Accessibility Evaluation

Monroe County Polling Location

Jackson Creek Middle School
3980 S Sare Rd
Bloomington, IN 47401

Report Date: 04/20/2026

Finding: 2

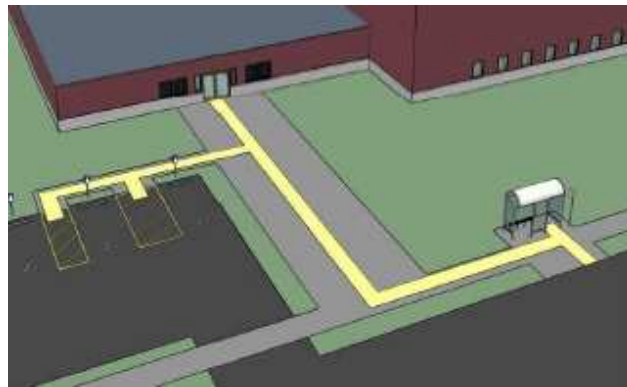
The accessible parking is located at a significant distance from the entrance.

Accessible parking spaces serving a particular building shall be located on the shortest accessible route of travel from parking to an accessible entrance. Where parking serves more than one accessible entrance, accessible parking spaces shall be dispersed and located closest to the accessible entrances.

Recommend using cones and temporary signage to create several angled accessible parking spaces and access aisles in the bus drop-off lane.
